Wollongong Local Planning Panel Assessment Report | 24 July 2019

WLPP No.	Item 1
DA No.	DA-2018/1032
Proposal	Residential - Demolition of existing dwelling and outbuildings and construction multi dwelling housing and Subdivision - strata title - four lots
Property	18 Hopetoun Street, Woonona NSW 2517 Lot B DP 157627
Applicant	MMJ Wollongong (Luke Rollinson)
Responsible Team	Development Assessment & Certification – City Wide Planning Team (JW + MB)

ADDENDUM REPORT

MANOEUVRING PLAN – ENTERING

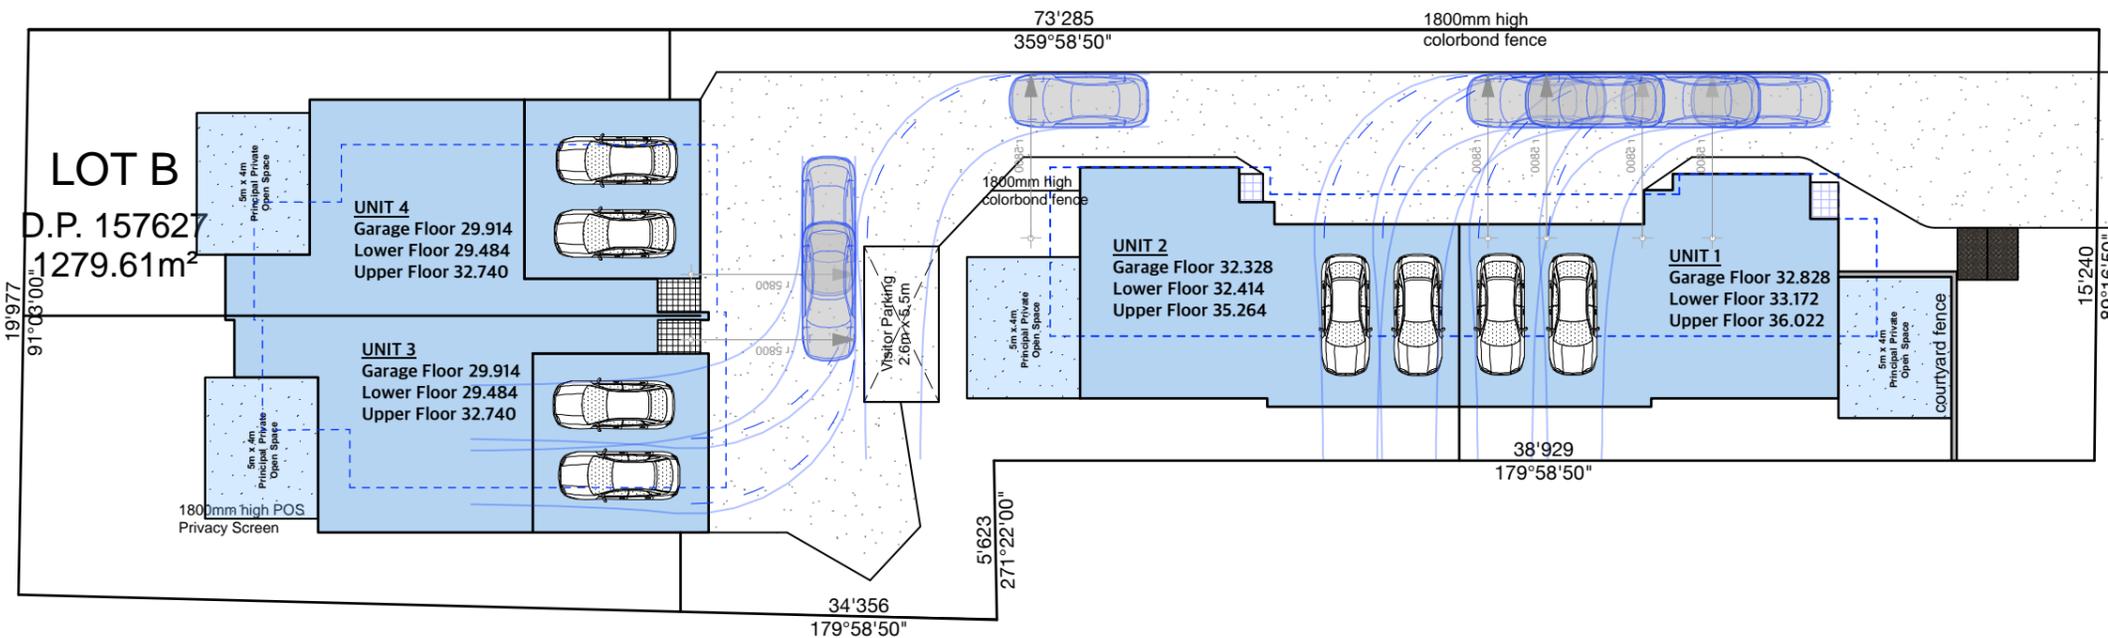
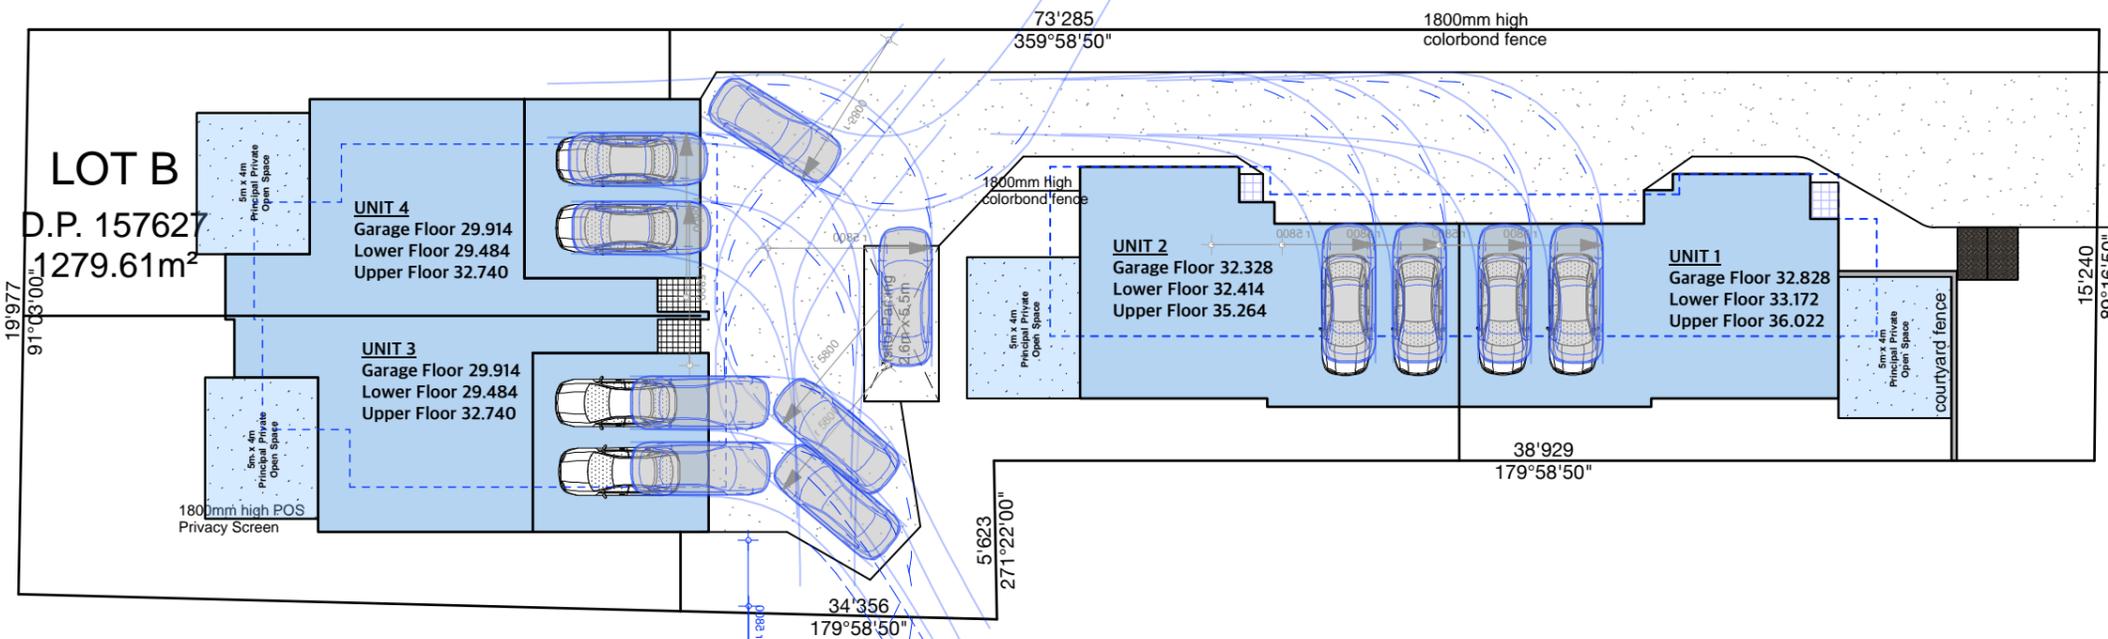
Updated traffic movement plans provided to demonstrate ingress/egress manoeuvrability in accordance with this requirement.

The applicant has provided amended plans that show vehicles occupying all parking spaces including the visitor space can enter and leave the site in a forward direction.

PROJECT
Landscape concept plan

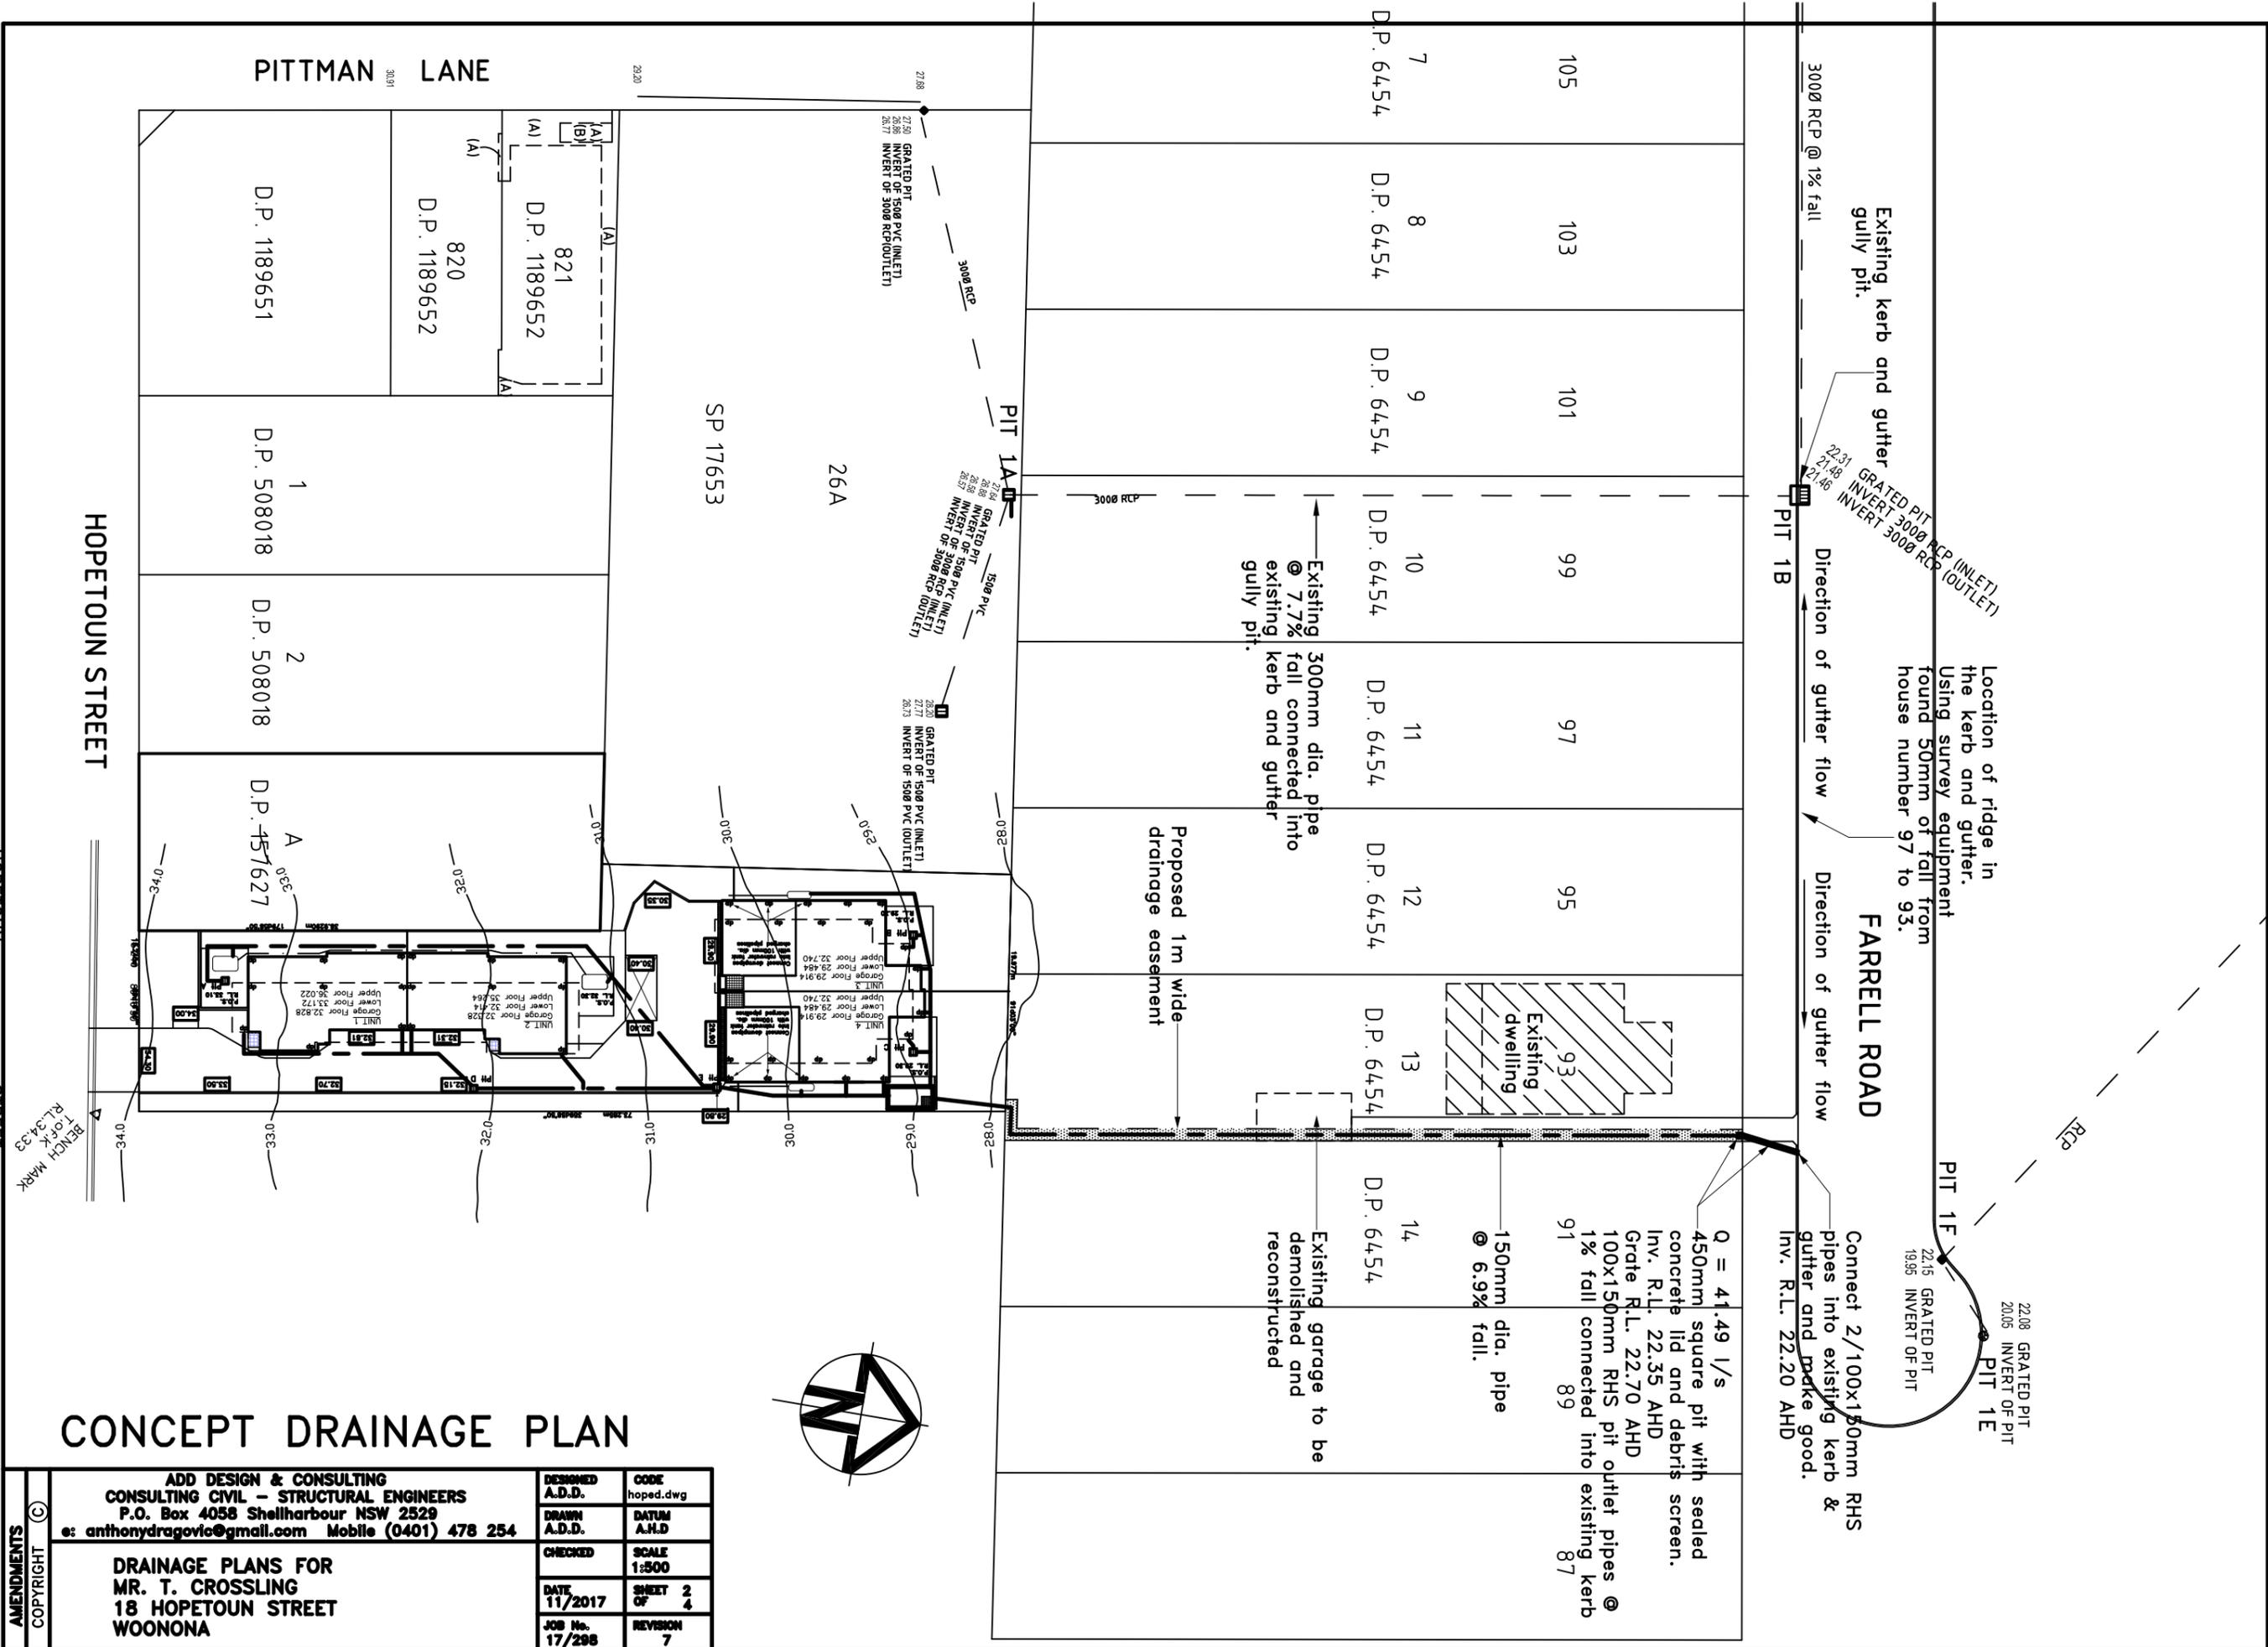
6. Change the proposed planting on the east and west boundaries to Lili-Pilli or similar.

The amended proposal was reviewed by Councils Landscape Architect who identified inconsistencies with the Site Plan and Landscape Plan which led to uncertainty with the landscape calculations, these inconsistencies have since been removed and the proposal is consistent with Council's Development Control Plan in respect to landscape requirements. The minor nature of the changes required by the landscape officer was subsequently made by the applicant. It was not considered necessary to re-refer the application to the landscape officer. It is considered that the proposal is satisfactory in this instance with appropriate conditions of consent recommended.

The applicant has submitted an amended landscape plan that now provides Lili-Pilli and Bottlebrush trees of a minimum 4.5 litre pot size. The planting of Lili-Pilli's on the eastern and western boundaries of the site will be included in conditions of consent for the development to ensure compliance with the Landscape Concept Plan. The revised conditions list is within **Attachment 5**.
